MCCRACKEN & LIVINGSTON BRIDGE US 60 OVER TENNESSEE RIVER

VALUE ENGINEERING STUDY
Prepared by URS Corporation
for Kentucky Transportation Cabinet

**VALUE ENGINEERING STUDY
for the
Kentucky Transportation Cabinet**

Final Report

Traditional 3-Span Parallel Chord Through Truss

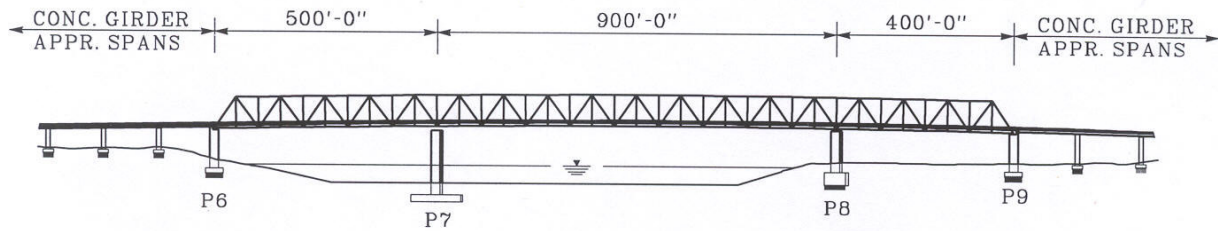
This 3-span traditional parallel chord through truss is based upon the existing US-60 over Tennessee River design with the following modifications:

- Remove the lateral sway bracing and replace with a moment resisting frame to improve the appearance
- Redesign the truss to reduce quantity of steel. Current design has approximately 125 psf of structural steel, other parallel chord truss bridges with similar span lengths and widths (Taylor-Southgate, Cincinnati, OH and I-526 Bridge over the Cooper River, Charleston, SC) have about 83 and 95 psf of structural steel, respectively (approximately \$5,750,000 savings with steel reduction).

- Even though this modified truss will have improved aesthetics, it is the team's opinion that this design will not be as aesthetically appealing as the truss in Alternate 32 or other bridge types discussed in this report.
- Requires additional time and effort to redesign the truss; however, the cost of redesigning will be more than offset by the savings from reducing quantity of steel required.
- Removal of lateral sway bracing will require larger top lateral bracing members with more complicated connections.
- The steel will need to be painted and on-going maintenance on the painting for the life of the structure.

Modified 3-Span Parallel Chord Through Truss

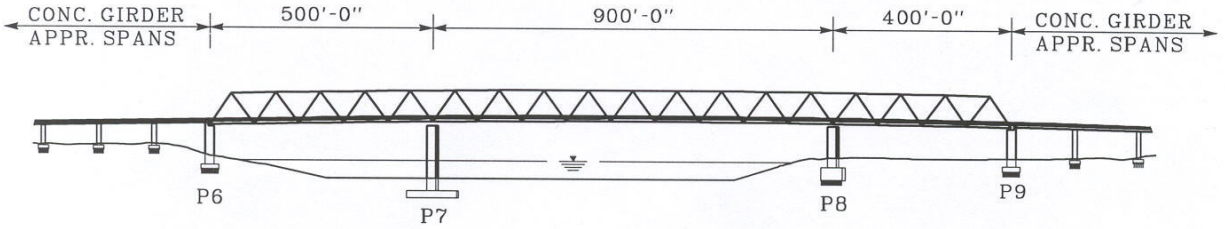
This alternate is the same as Alternate 1 with the exception that the detailing of the truss will be enhanced to provide higher aesthetic appeal. First, the vertical elements of the truss will be eliminated and the diagonals will carry the entire load. Second, the number of members for the top chord lateral bracing will be reduced in an effort to improve the appearance. Both of these revisions are meant to create a clean and distinctive truss system with improved aesthetics; however, these revisions also have the affect of complicating the connections and decreasing the efficiency of some of the members, both of which will increase the cost slightly.

- Requires painting of the structural steel.
- The removal of the verticals and the reconfiguration of the top lateral bracing is not as structurally efficient as Alternate 1.

DECK TRUSS
(ALTERNATE 12)

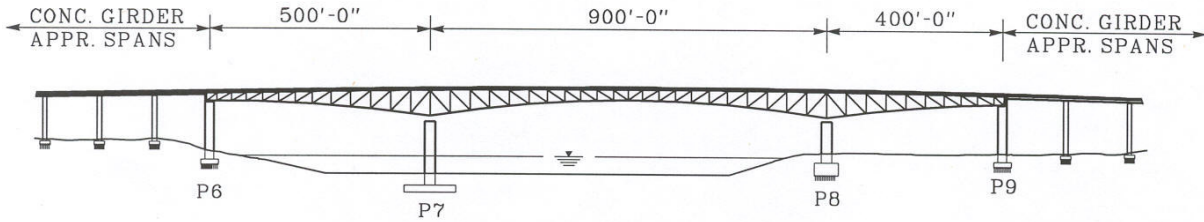
- Deck truss structures can make for relatively pleasing bridges.
- Construction of the mainspan can be performed without the need for temporary works within the navigation channel.
- Structural steel can be unpainted weathering steel since all steel is below deck.
- Relatively cost-effective system.
- Existing construction contract for Piers 7 and 8 will probably not need to be modified. For this alternate the concrete deck is placed higher above the water and therefore, the impact to the seismic evaluation to the Pier 7 and 8 foundation needs to be confirmed.

EXTRADOSED STEEL GIRDER BRIDGE
(ALTERNATE 11)

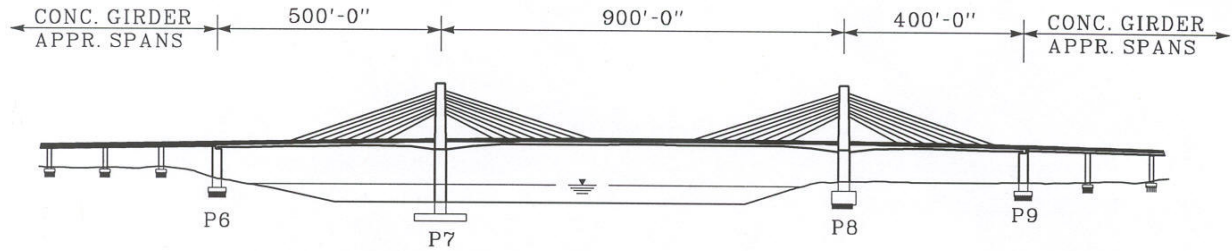
An extradosed bridge is a hybrid between a cable-stayed bridge and a true girder bridge. For a true cable-stayed bridge the superstructure is extremely thin and flexible and requires the stay-cables to provide nearly 100% of the support. On the other hand, a girder bridge has a deep and stiff superstructure that can span between piers without the aid of stay-cables. An extradosed bridge is somewhere in between the cable-stayed and girder bridge, using a girder that is shallower than a girder bridge but deeper than a cable-stayed bridge, therefore small cables are needed to assist in the superstructure support. Typically, the towers are relatively short compared to a cable-stayed structure and the cables are only provided along a portion of the span.

This alternate calls for a three span extradosed steel girder bridge with a plane of cables along each edge of the roadway. The foundations and piers associated with this alternate are not consistent with the piers under the existing construction contract; therefore the contract with C.J. Mahan would need to be terminated.

CABLE-STAYED BRIDGE WITH 900-FT SPAN
(ALTERNATE 7)

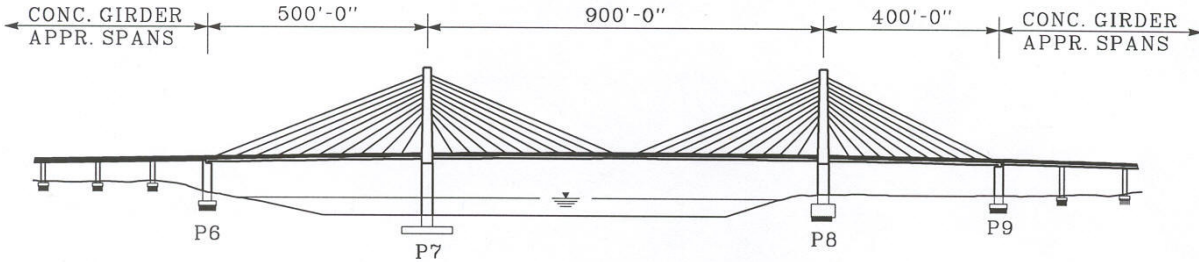
This alternate consists of a traditional 3-span symmetrical cable-stayed bridge with two planes of cables, one along each roadway edge. This alternate would require that the existing construction contract for Piers 6 to 9 be terminated and the piers/foundations be redesigned to accommodate a cable-stayed bridge.

VALUE ENGINEERING DESIGN COMMENT # 1

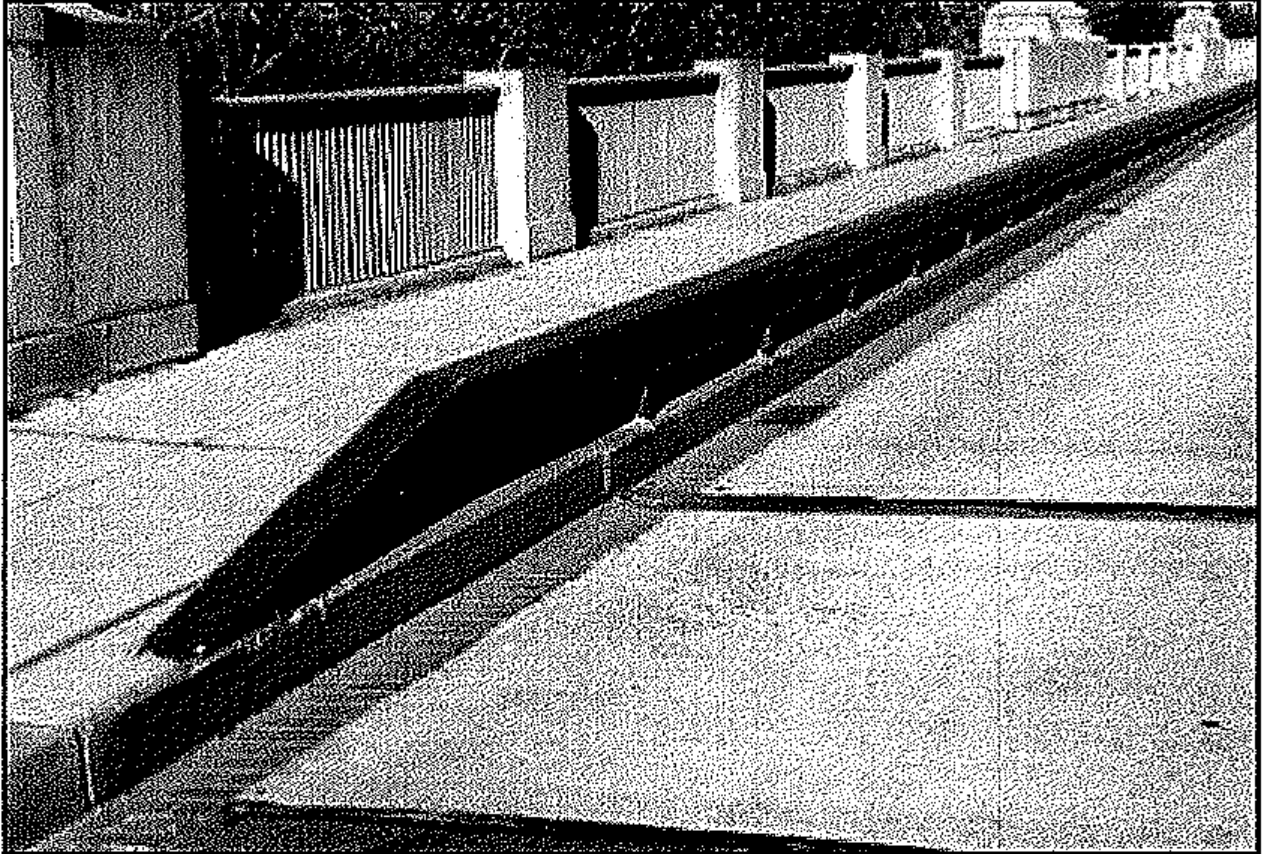
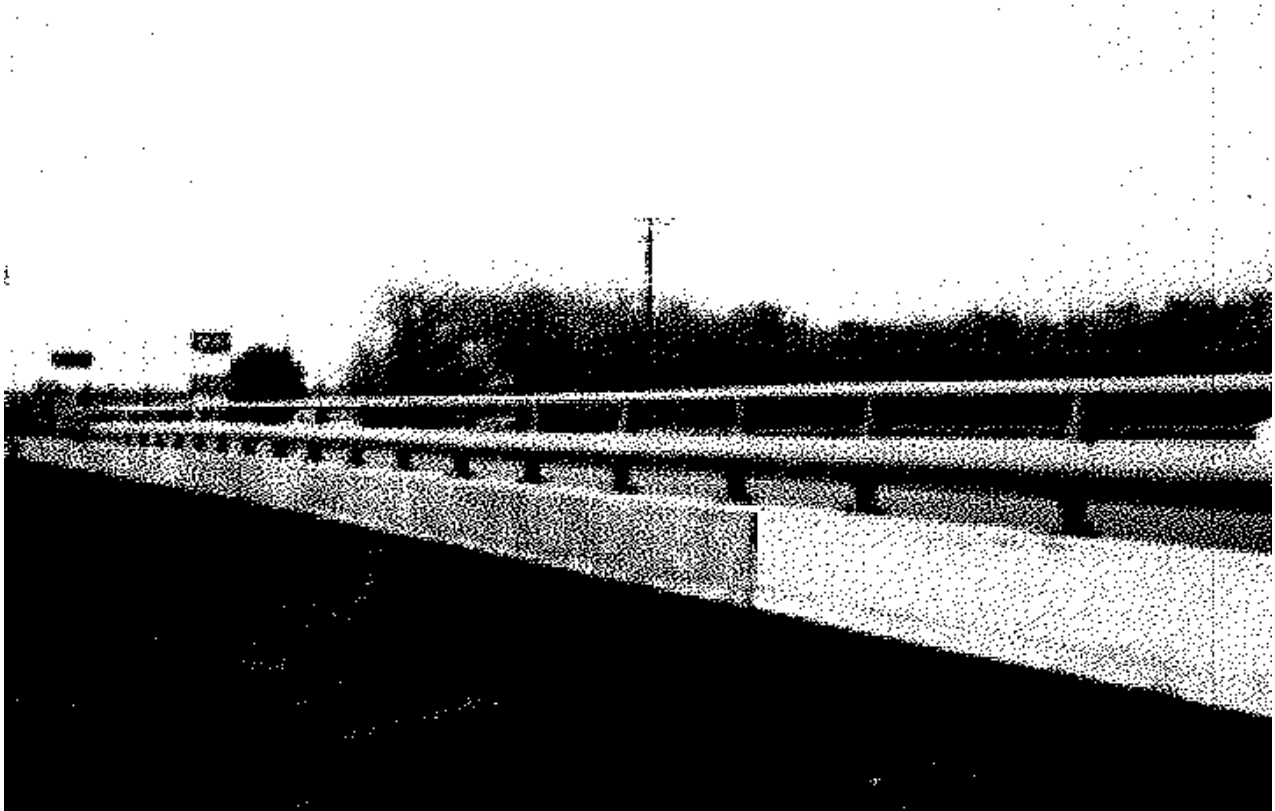
Use tube rail in lieu of jersey barriers for sides and center medians.

The present design proposes using Jersey barriers for sides and center medians. Utilizing tube rail would provide more daylight and counter the box effect of the current truss design. A rail would also provide a better scenic view of the river and its surroundings. Given the reduced shoulder width of 4 feet as designed; this would give the appearance of a wider bridge. Sketches of several railing types are attached.
